Dominion Nuclear Connecticut, Inc.
Rope Ferry Rd., Waterford, CT 06385

Serial No. 14-625
NLOS/WDC R0
Docket No. 50-336
License No. DPR-65

DOMINION NUCLEAR CONNECTICUT, INC.
MILLSTONE POWER STATION UNIT 2
RESPONSE TO SECOND REQUEST FOR ADDITIONAL INFORMATION REGARDING
PROPOSED TECHNICAL SPECIFICATION CHANGE FOR SPENT FUEL STORAGE

Figure 21.1 Radial Cut of the Poison Box

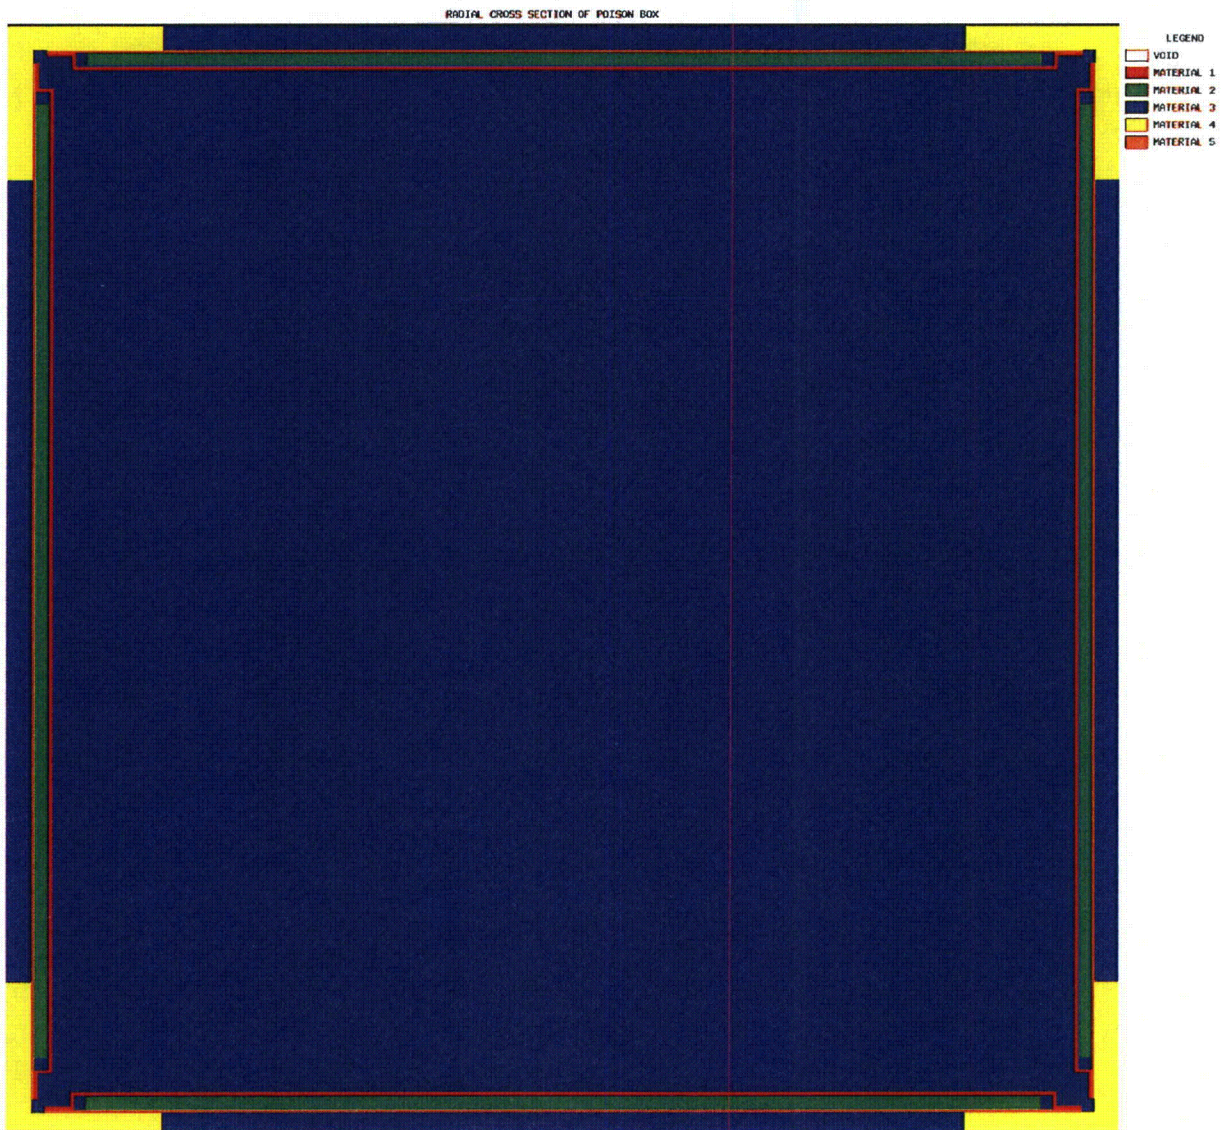
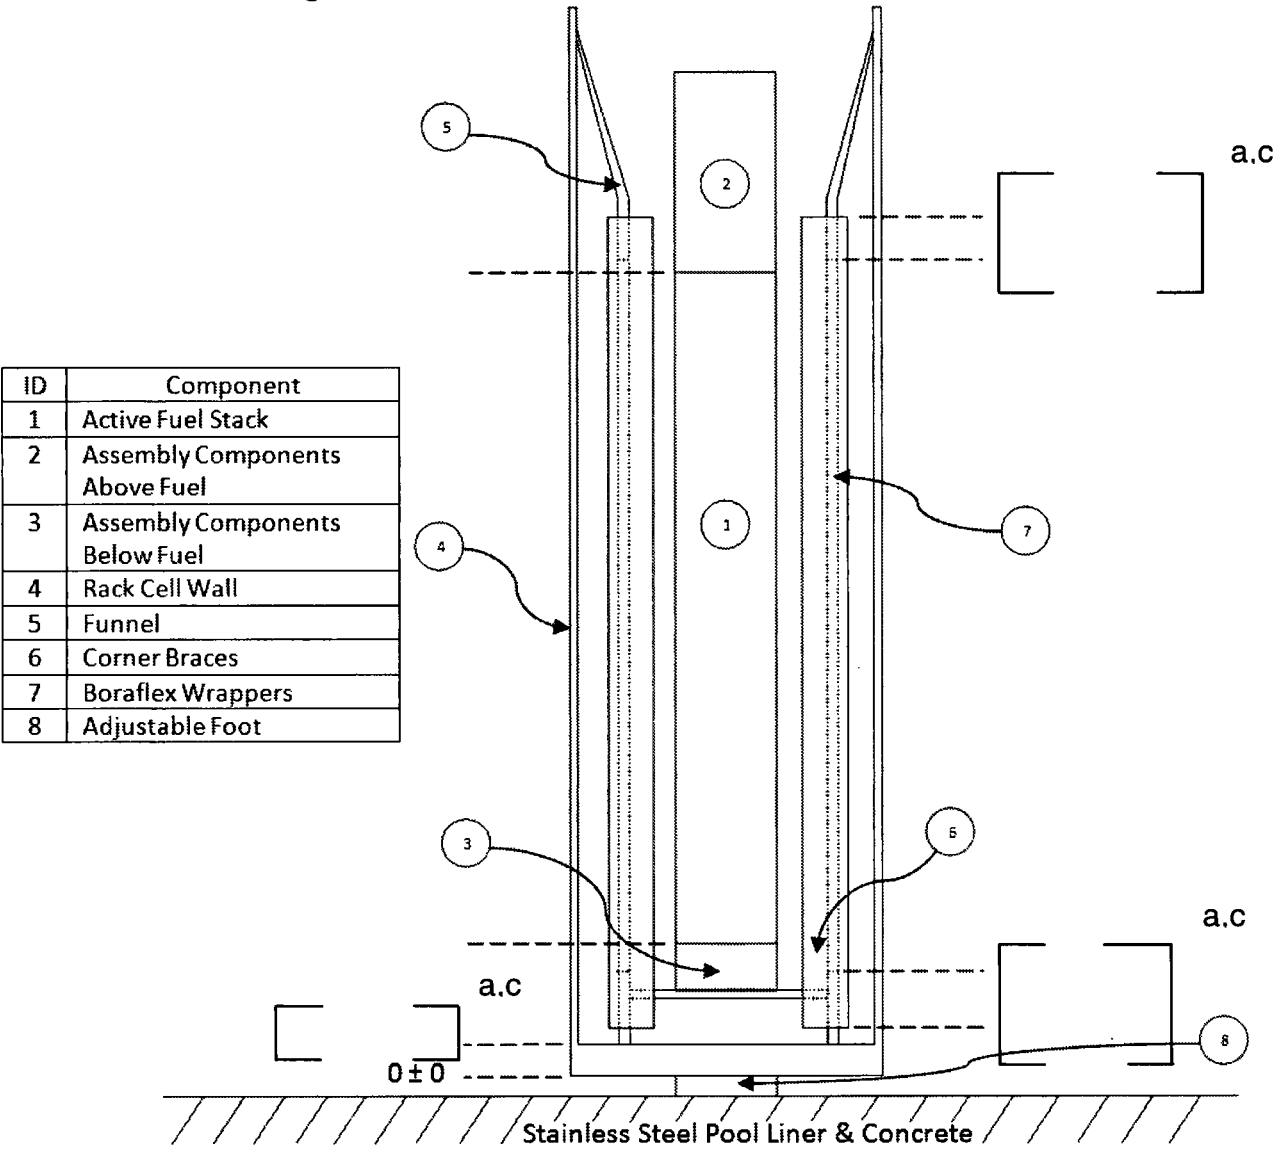
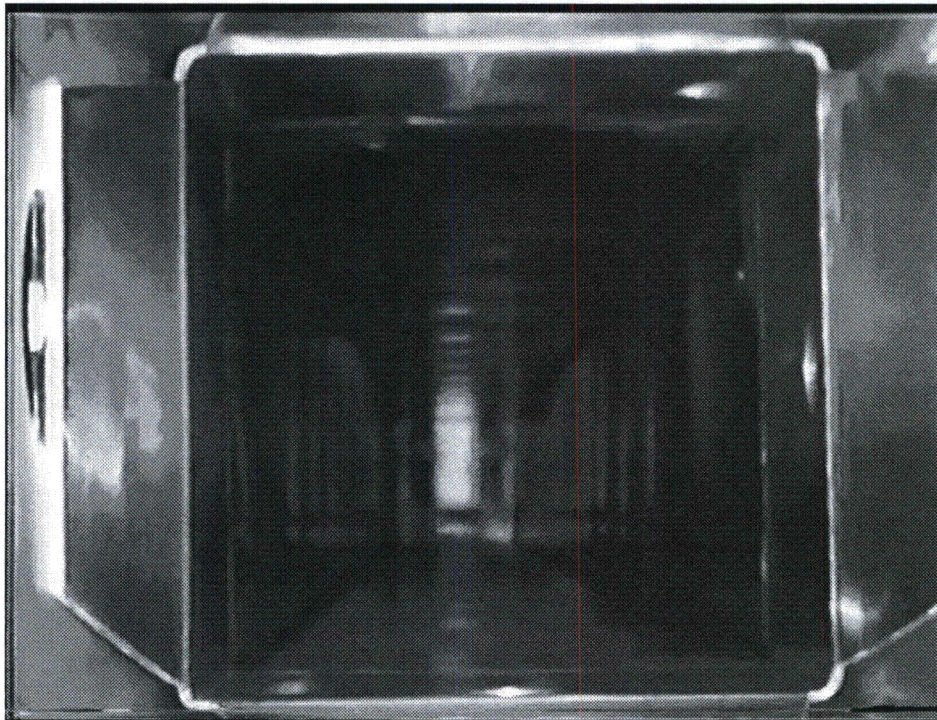
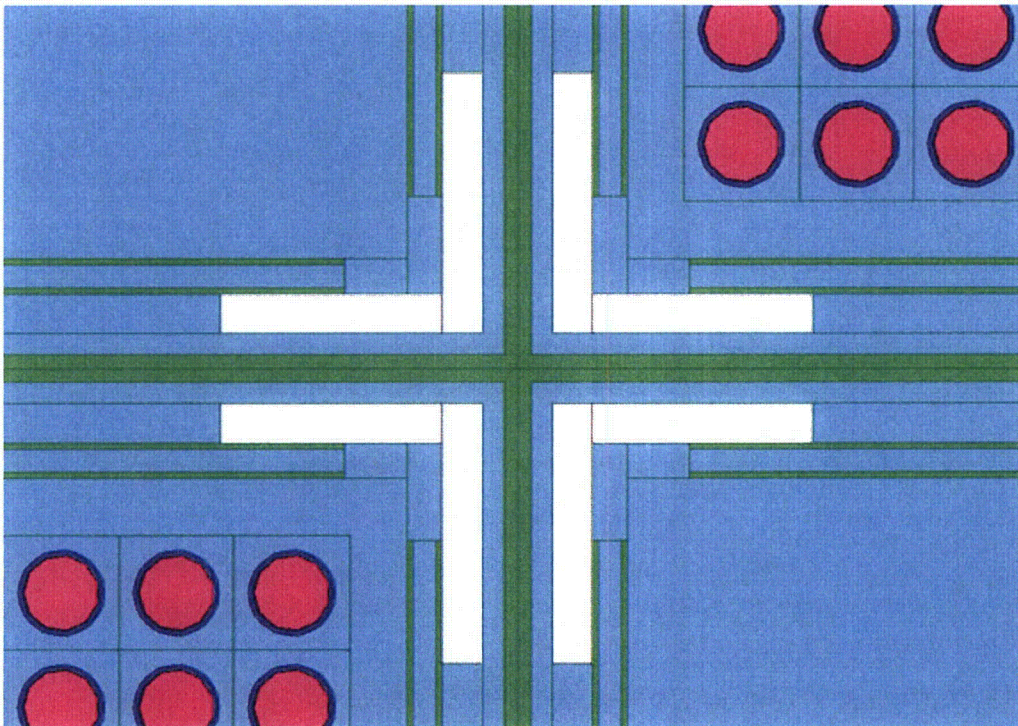
- e. From the text in Section 4.2.1, there should be a []^{a,c} thick steel plate on both the inside and outside of the poison gap in the poison box. From Figure 6.1-6, it looks like the cover sheet is missing off of the outside of the poison box. Review the Region 1 and 2 models to confirm the models are correct. If they are not correct, either revise the analysis or provide an evaluation of the impact of the modeling error.*

Figure 21.1 is an x-y cut of a poison box at the active fuel level. Figure 21.2 provides the axial features of the poison box in the rack cell with fuel. Figure 21.3 features two photographs of the top of a poison box.

- b. In the active region of the fuel the poison box structure consists of two components (stainless steel wrappers and corner braces). The ASTM standard tolerance on stainless steel sheet thickness is 0.002 inches for thicknesses between 0.02 and 0.035 inches. [Ref. 21.1] A conservative 0.003 inch tolerance has been added to the analysis. Further, although the cover and back sheet are separate pieces, it is assumed they are both simultaneously either at the minimum or maximum thickness.

The stainless steel corner braces are []^{a,c} wide, []^{a,c} thick, and have a thickness tolerance of []^{a,c}. Wrapper thickness cases show that increasing stainless steel in Regions 1 and 2 decreases k_{eff} with 0 ppm soluble boron. With 2000 ppm boron, the wrapper thickness tolerance effect is too small to affect the total uncertainty calculation. Therefore, only the []^{a,c} inch tolerance is of interest. This tolerance is ignored because in the Region 1 and 2 KENO models the portion of the stainless steel wrappers extending beyond the Boraflex region is not modeled (2 thicknesses of []^{a,c} thick stainless steel approximately []^{a,c} long). This portion of the wrappers may be visualized by comparing the Boraflex wrappers in Figure 21.4 (as modeled) and Figure 21.1 (idealized). In addition, the wrapper tolerance used is 0.003 rather than 0.002 inch, which provides additional conservatism to adequately cover the corner brace thickness uncertainty.

- c & d. The poison boxes are centered by the funnel section of the poison box which is compressed and snapped into a slot in the rack cell walls. See Figure 21.3 for the funnel sections. A Region 1 calculation was performed with the poison boxes shifted toward the corner of the rack cell such that the corner brace contacts the rack cell wall. The reactivity effect was 0.0002 dk which is too small to have an effect after the statistical combination of the uncertainties.
- e. Although not easily visible in Figure 6.1-6 of the December 2012 LAR, both the inside and outside panels of stainless steel were in the model. Figure 21.4 is an expanded view of the model that shows both panels.

FIGURE 3.9-1A MINIMUM REQUIRED AVERAGE FUEL ASSEMBLY BURNUP AS A FUNCTION OF INITIAL ENRICHMENT TO PERMIT STORAGE IN REGION 2A

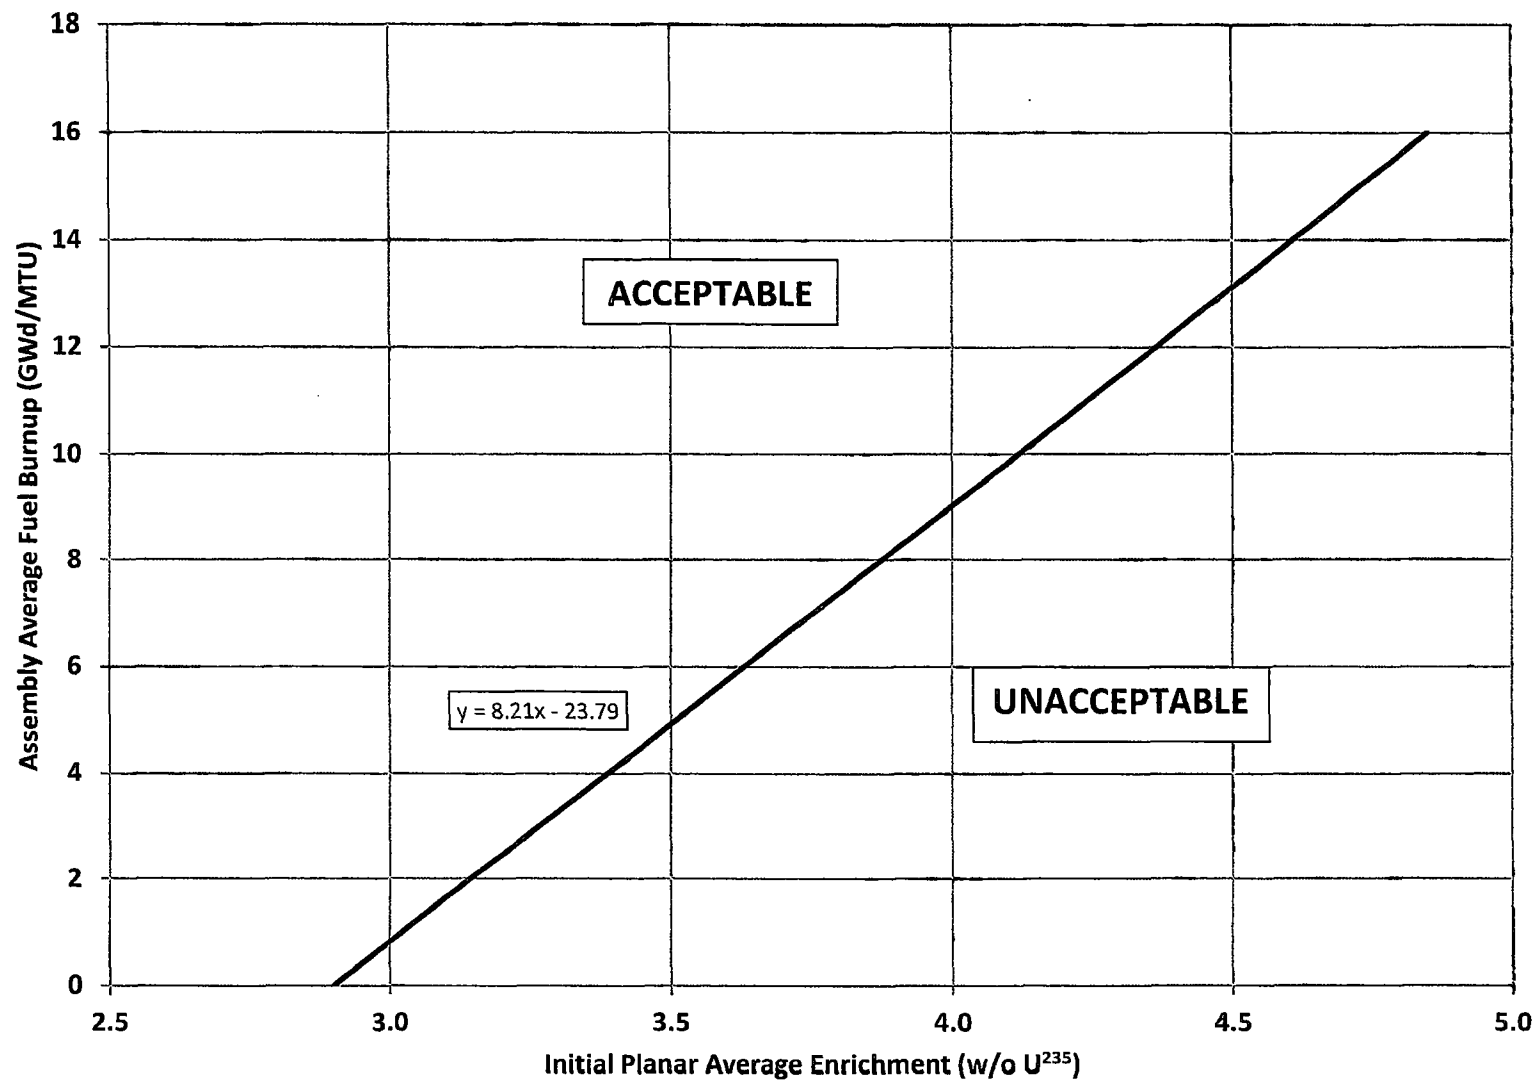
TS Figure 3.9-1A is revised. This figure shows the minimum required fuel assembly burnup as a function of initial planar average enrichment to permit storage of fuel assemblies in Region 2 within storage locations designated as Type 2A.

FIGURE 3.9-1B MINIMUM REQUIRED AVERAGE FUEL ASSEMBLY BURNUP AS A FUNCTION OF INITIAL ENRICHMENT TO PERMIT STORAGE IN REGION 2B

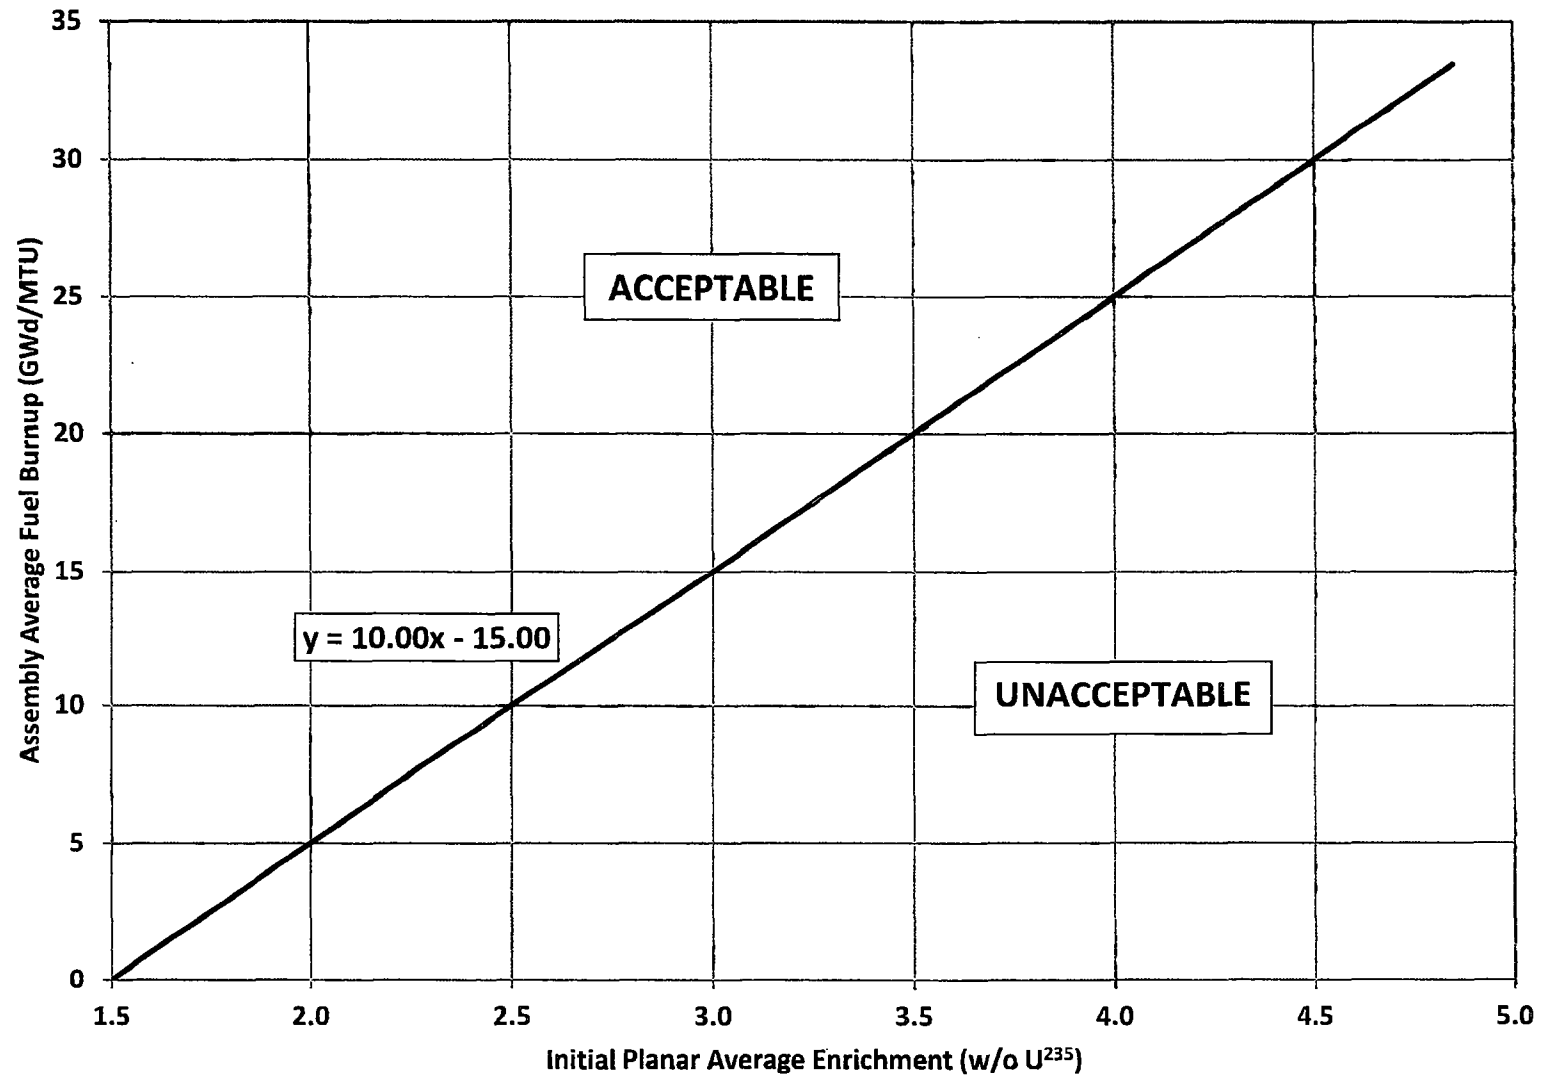
TS Figure 3.9-1B is revised. This figure shows the minimum required fuel assembly burnup as a function of initial planar average enrichment to permit storage of fuel assemblies in Region 2 within storage locations designated as Type 2B. Region 2 Type 2A storage locations can store higher reactivity fuel assemblies than Region 2 Type 2B.

FIGURE 3.9-1C MINIMUM REQUIRED AVERAGE FUEL ASSEMBLY BURNUP AS A FUNCTION OF INITIAL ENRICHMENT TO PERMIT STORAGE IN REGION 3 (with insertion of 3 Borated Stainless Steel Poison Rodlets)

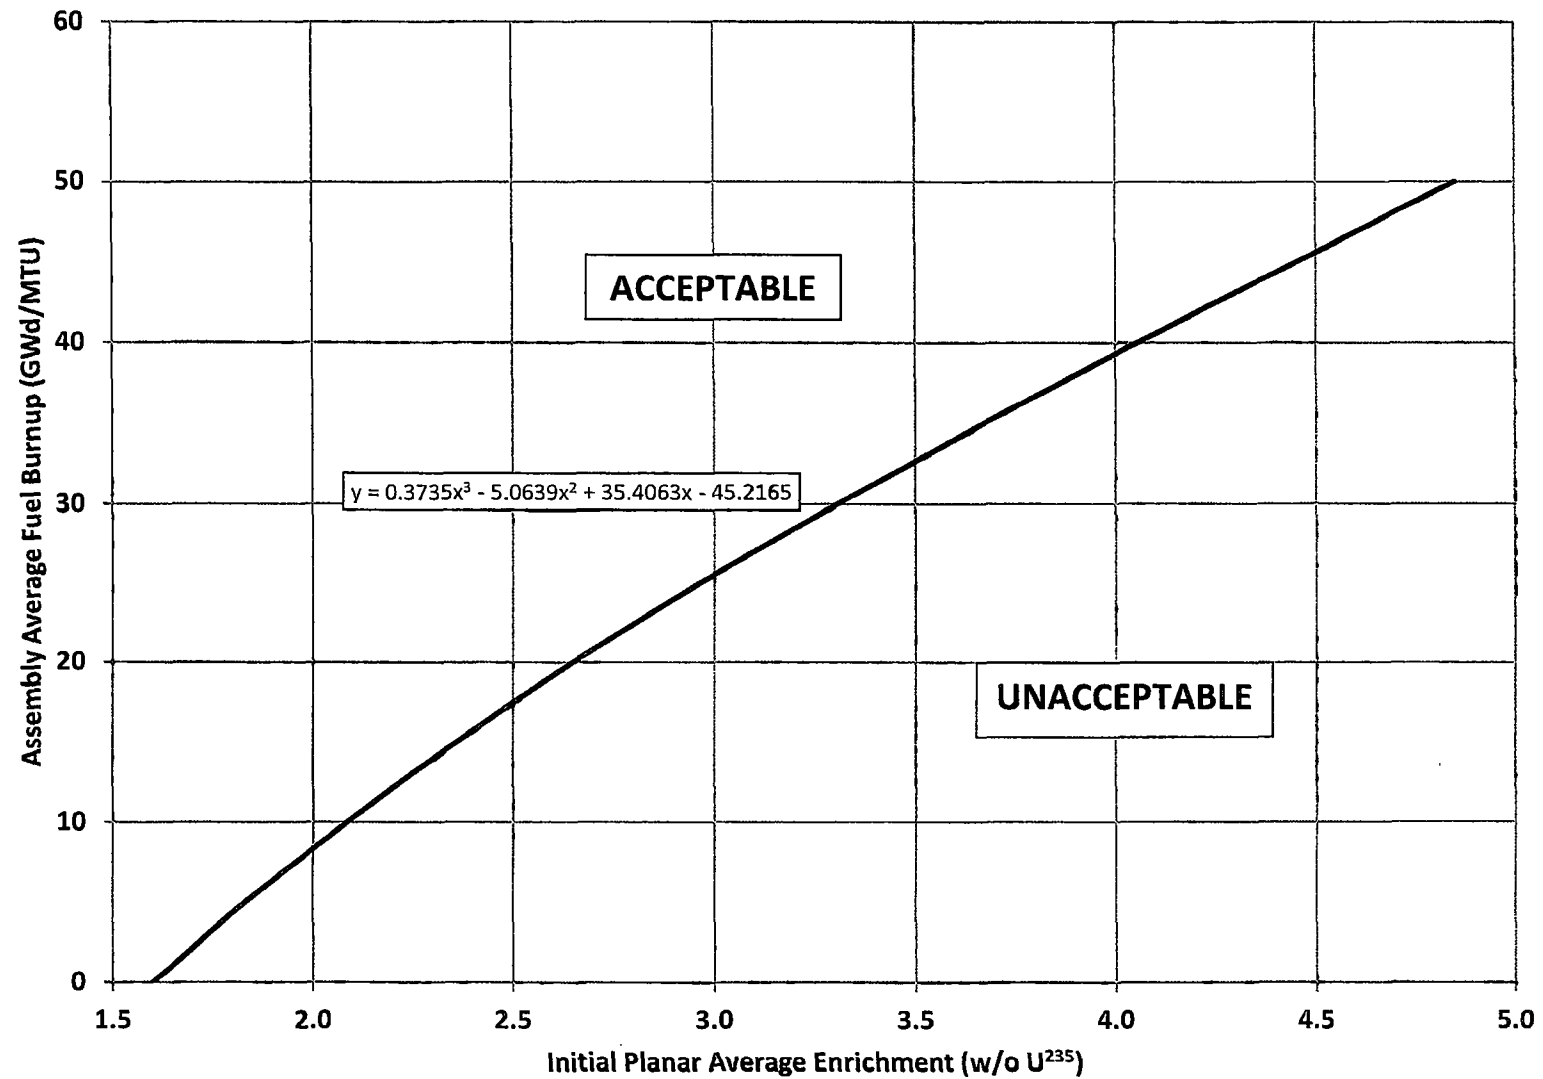
TS Figure 3.9-1C is a new figure. This figure shows the minimum required fuel assembly burnup as a function of initial planar average enrichment to permit storage of fuel assemblies containing rodlets in Region 3.
